Project: SWVTC – Replace Ductwork in Buildings 1, 2, 9 and 10  
Project Code: 720-10880-38-11

RE: **Addendum No. 3**

**Addendum No. 3, dated August 19, 2009, to Bidding Documents for Southwestern Virginia Training Center – Hillsville, Virginia: Replace Ductwork in Buildings 1, 2, 9 and 10, Plans and Specifications dated May 22, 2009, K♦B File No. 08103, Project Code: 720-10880-38-11.**

By: DAC	Date: 17 AUG 09	Proj. No.: 08103	Rev: 1	SK No.: SK-1
Client: COMMONWEALTH OF VIRGINIA DBHDS				DWG No.: 08103AE02
Project: SOUTHWESTERN VIRGINIA TRAINING CENTER				Page: 1 of 8
Subject: REPLACE DUCTWORK BUILDINGS 1, 2, 9, AND 10

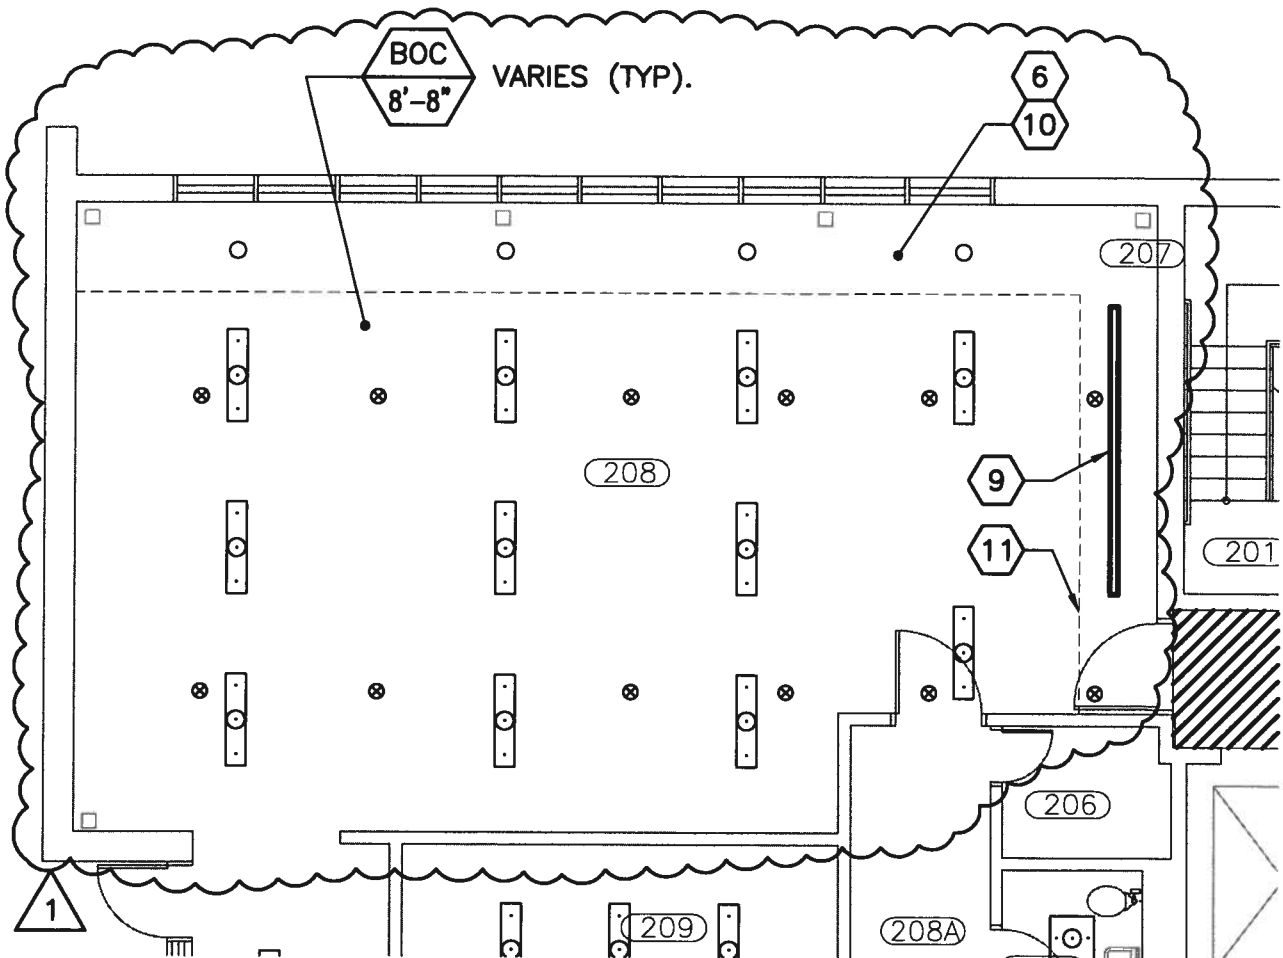
- See attached Sketch No. SK-1.
- See attached Sketch No. SK-2.

- 8 EXISTING MAKE-UP AIR UNITS TO BE REMOVED COMPLETELY, REFER TO MECHANICAL DRAWINGS. TEMPORARILY SEAL ALL CEILING AND ROOF PENETRATIONS.
  - 9 DISCONNECT AND REMOVE EXISTING ELECTRICAL RACEWAY.
  - 10 REMOVE HARD CEILING/SOFFIT THIS AREA.
  - 11 SOFFIT TO REMAIN IN PLACE UNDISTURBED.
- 1
